Re: IMU Daughter Card Design

Here are some notes for how to design the daughter card.

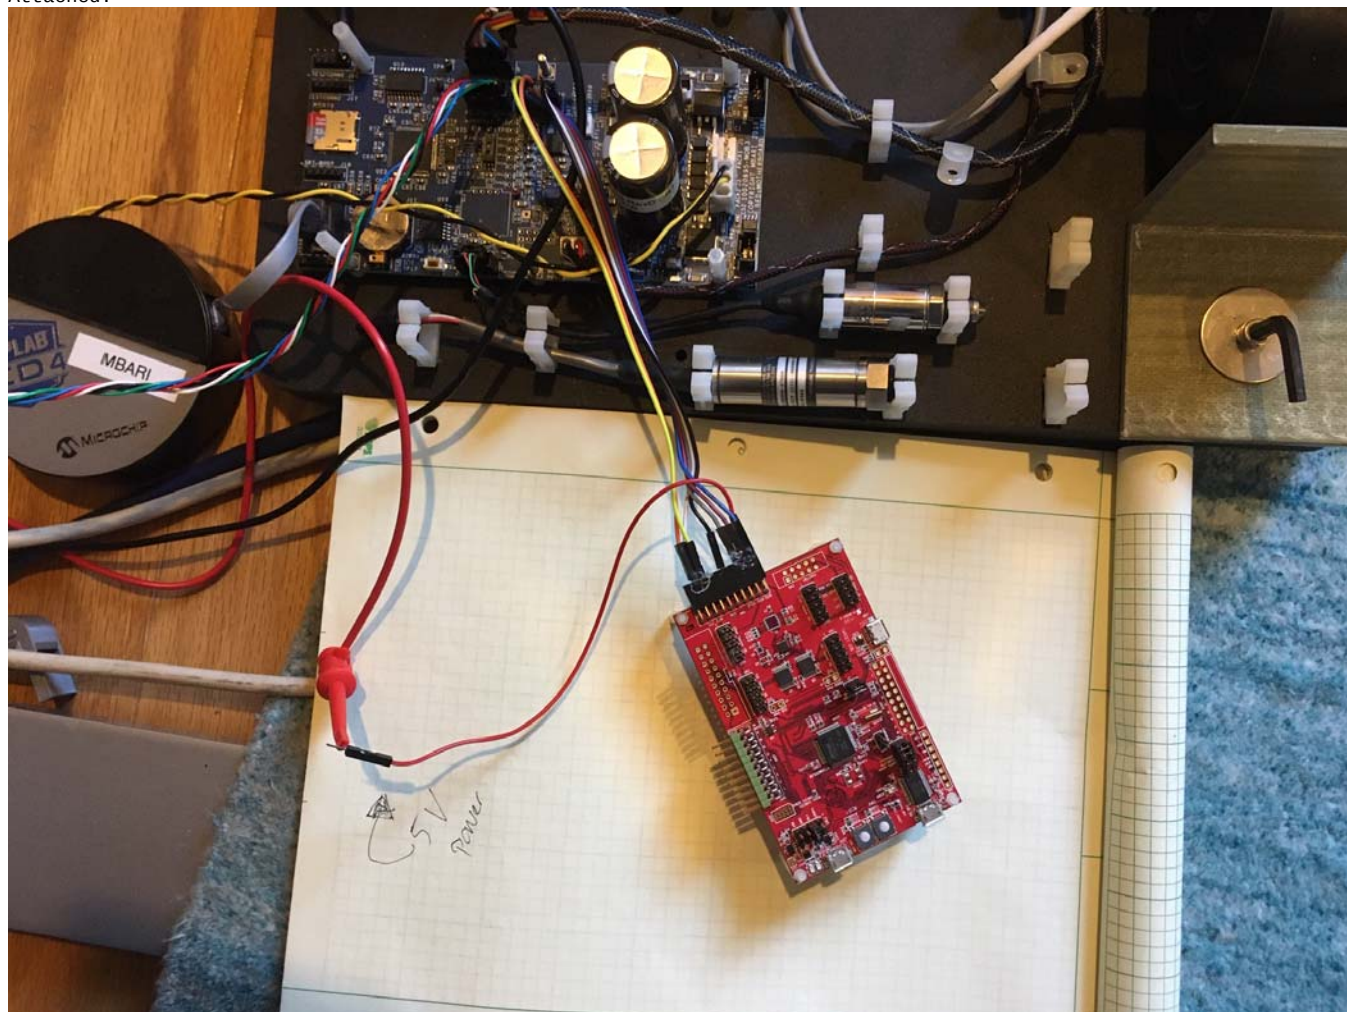
- could you send the photo of MB3 with your prototype connected to it?

Attached.
